# SAFETY BULLETIN 160502

**Subject:** Potential Improper Makeup of Industrial Nuts and certain Female Components

**To:** Customers who have Received 1/2" Industrial Pipe Unions

### COMPONENTS

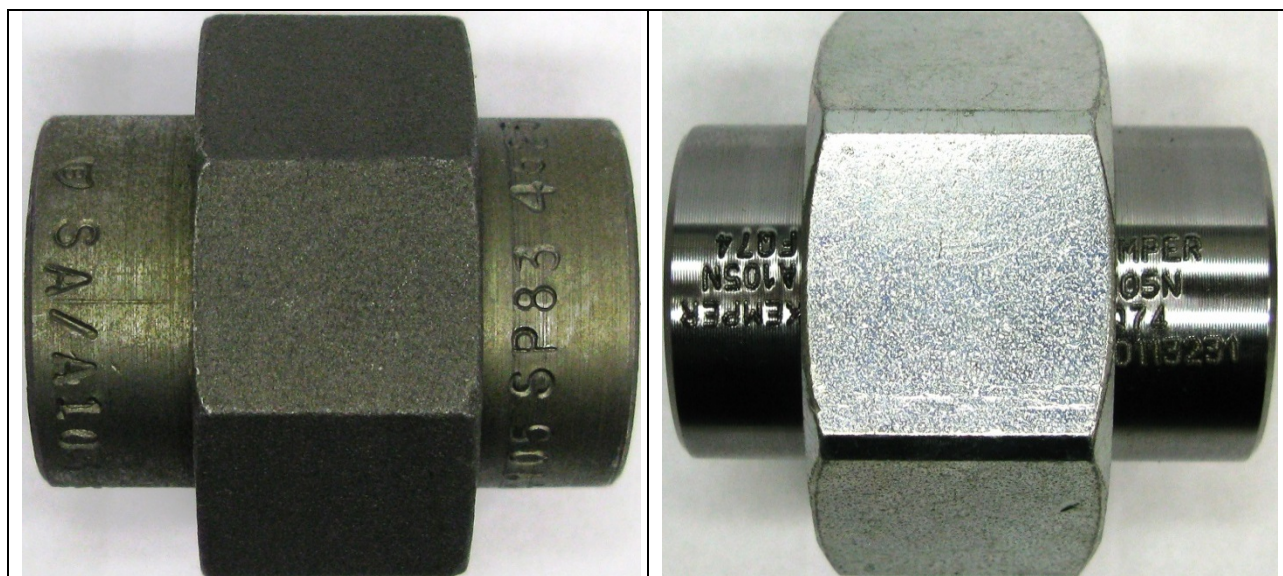
Kemper Valve and Fittings (KVF) sells two versions of its **1/2" INDUSTRIAL UNION**. They are sold and shipped in assembled sets. The **COMPONENT PARTS** (Male, Female, and Nut) are **NOT INTERCHANGEABLE** between the two versions. Doing so can lead to an improper make-up condition and can lead to leaking. Pictures of the two versions are attached. The differences between these two versions can be easily determined visually. Version 1 has a dark matte finish on all three components. Version 2 has a shiny, plated Nut and machined Male and Female component sealing surfaces.

**DO NOT MIX OR INTERCHANGE COMPONENTS**

**RESOLUTION:** Version 2 of ½" Industrial Unions is no longer offered for sale. Tabbed Orifice Cup ½" Industrial Unions are not currently available for sale.
